Proposal for Supplement 2 to the 01 series amendment text to UN Regulation No. 152 (Advanced Emergency Braking Systems for M₁ and N₁ vehicles)

The text reproduced below was prepared by the experts from the Informal Working Group on Advanced Emergency Braking Systems (AEBS) for vehicles of Categories M₁ and N₁ in order to supplement the proposals of document ECE/TRANS/WP.29/GRVA/2020/35 to improve the text on a number of issues. The modifications to the text of document GRVA/2020/35 are marked in bold for new and strikethrough for deleted characters.

Figure 1: LEFT TURN OR RIGHT TURN AT THE INTERSECTION

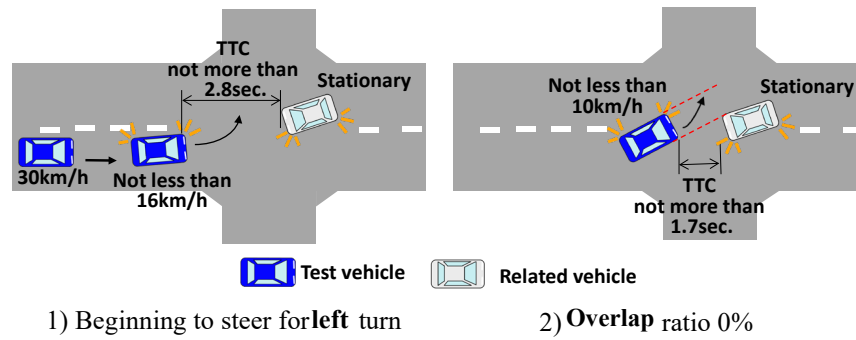
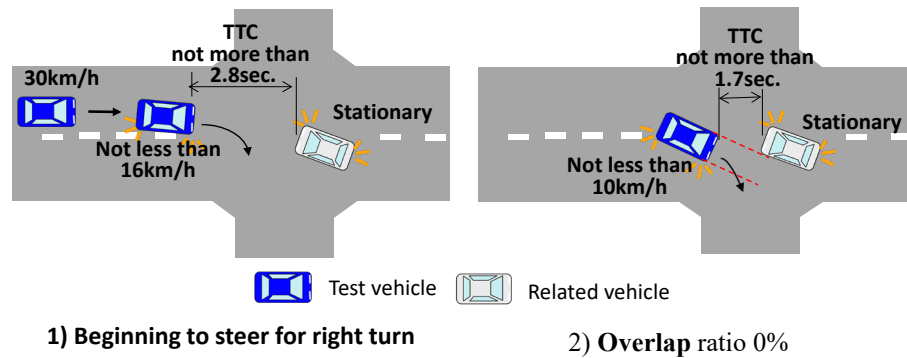
The TTC to the oncoming vehicle is not more than 1.7 seconds at when the ~~wrap~~ **overlap** ratio between the subject vehicle and the oncoming vehicle becomes 0%.

Change of “wrap ratio” into “overlap ratio” and introduction of a definition of “overlap ratio”. The proposed drawings are improved accordingly.

Figure 2: right turn or left turn of a forward vehicle

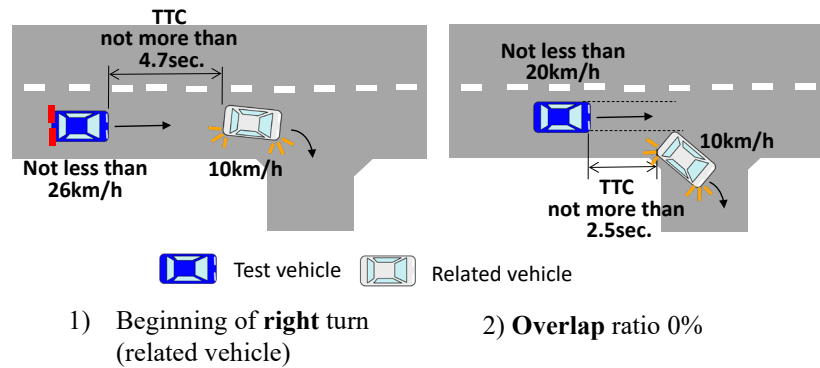
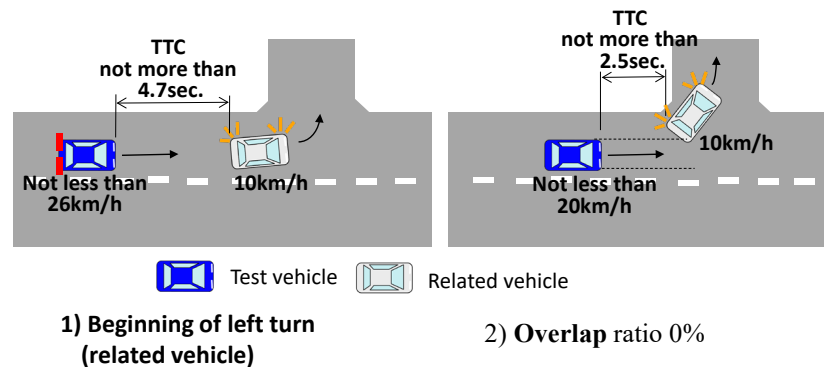
The TTC to the forward vehicle is not more than 2.5 seconds at when the ~~wrap~~ **overlap** ratio between the subject vehicle and the forward vehicle becomes 0%.”
